Your Ref
LU/51/19/HH
Our Ref
PLAN-027003
Date
21/03/2019

Proposal: Two storey side extension. Demolition of existing garage and outbuilding, construction of new annexe (Amendments to approved scheme LU/260/18/HH).
Site: 22 Roman Acre, Littlehampton, BN17 7HN.
LU/51/19/HH

Southern Water MapGuide Browser

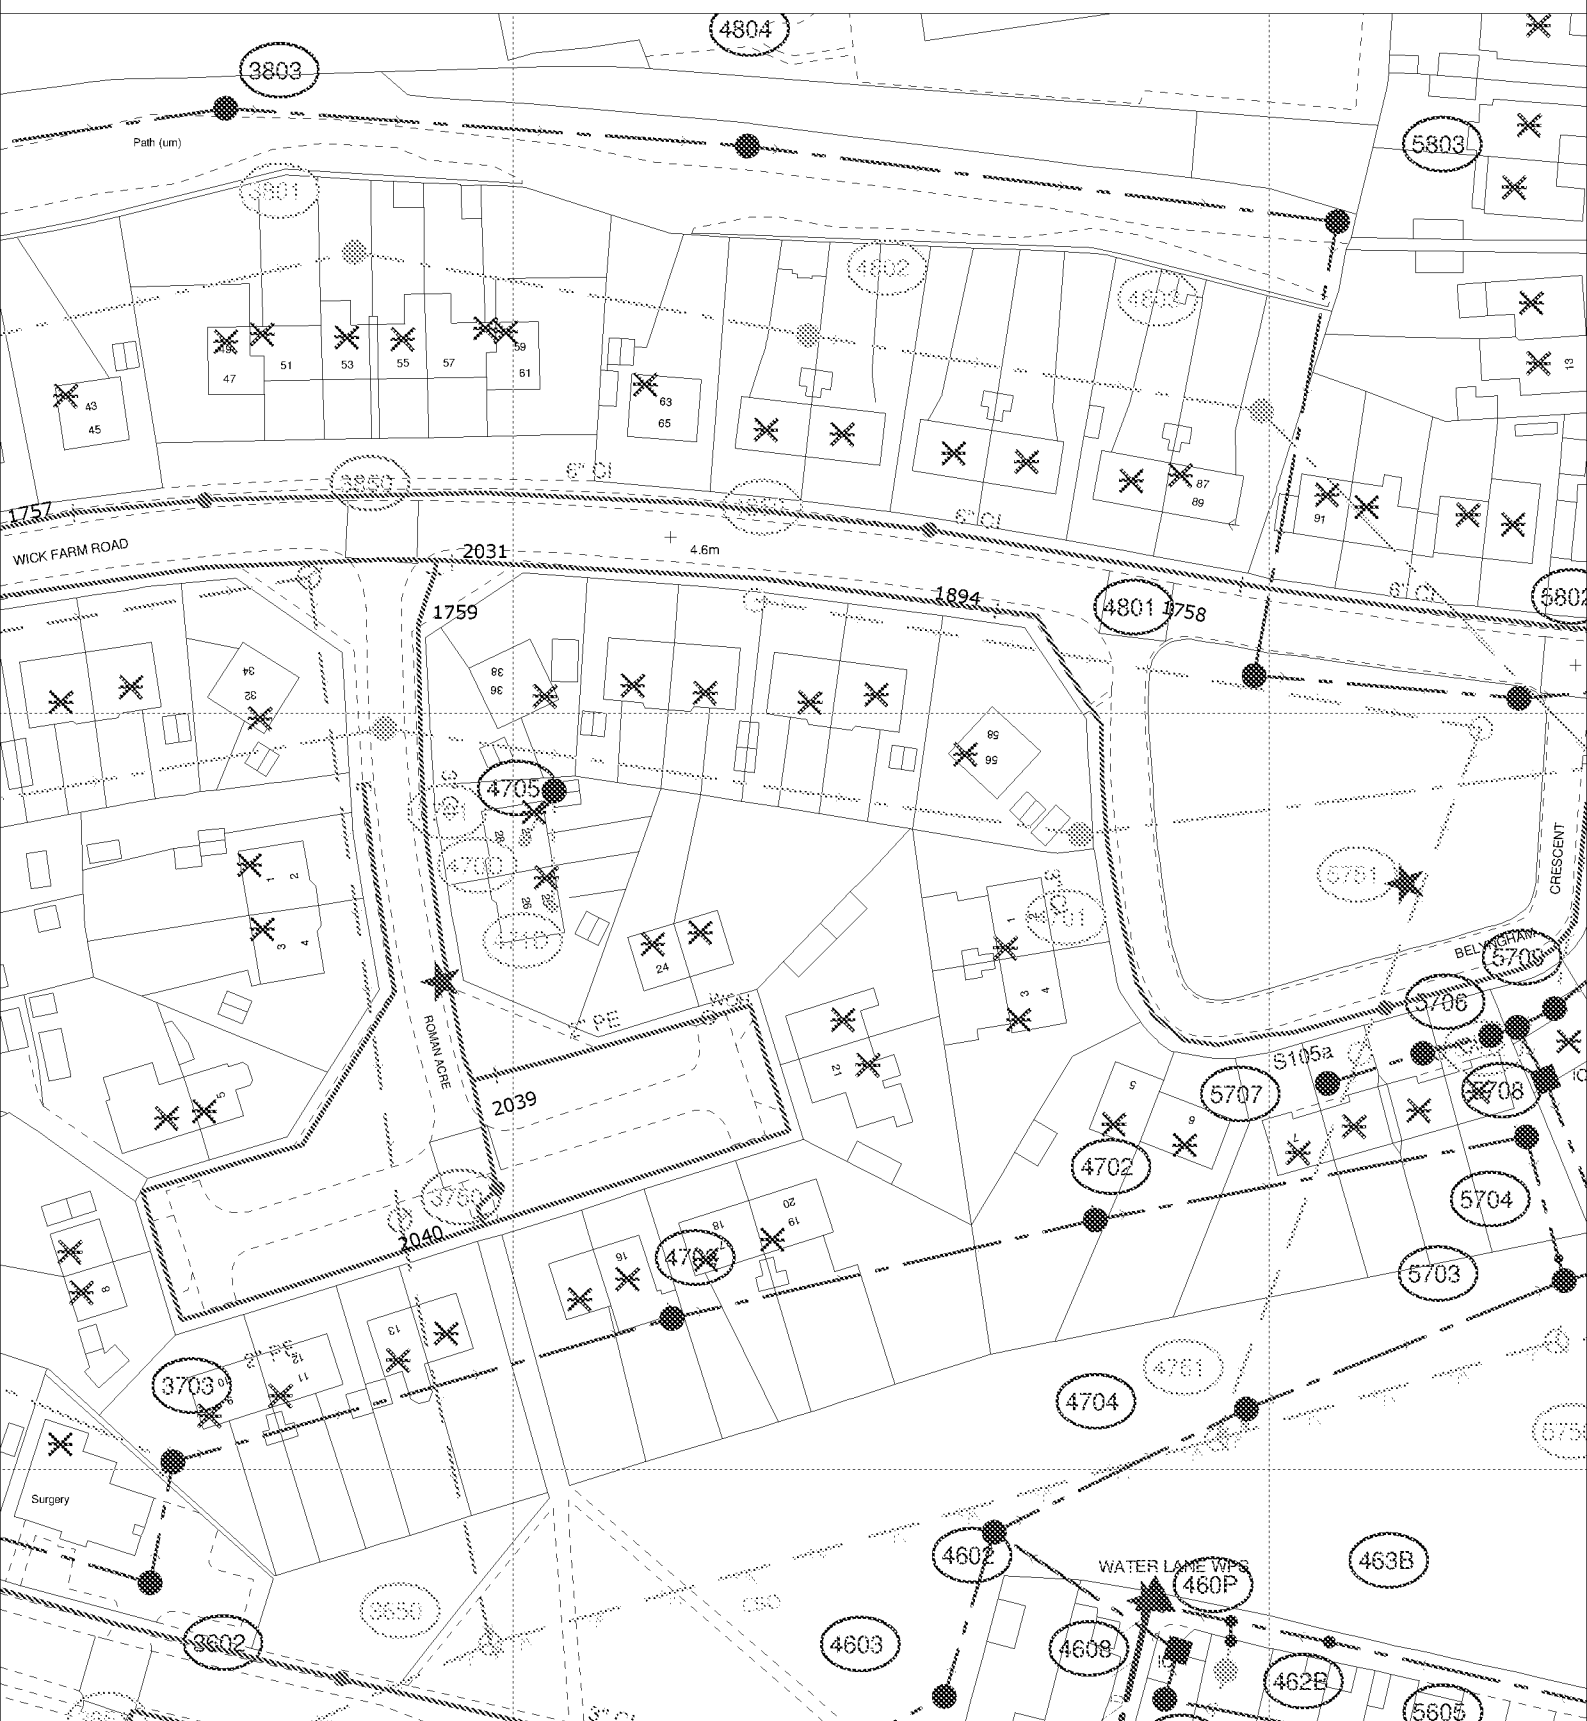
Due to changes in legislation that came in to force on 1st October 2011 regarding the future ownership of sewers, it is possible that a sewer now deemed to be public could be crossing the above property. Therefore, should any sewer be found during construction works, an investigation of the sewer will be required to ascertain its condition, the number of properties served, and potential means of access before any further works commence on site.

The applicant is advised to discuss the matter further with Southern Water, Sparrowgrove House, Sparrowgrove, Otterbourne, Hampshire SO21 2SW (Tel: 0330 303 0119) or www.southernwater.co.uk".
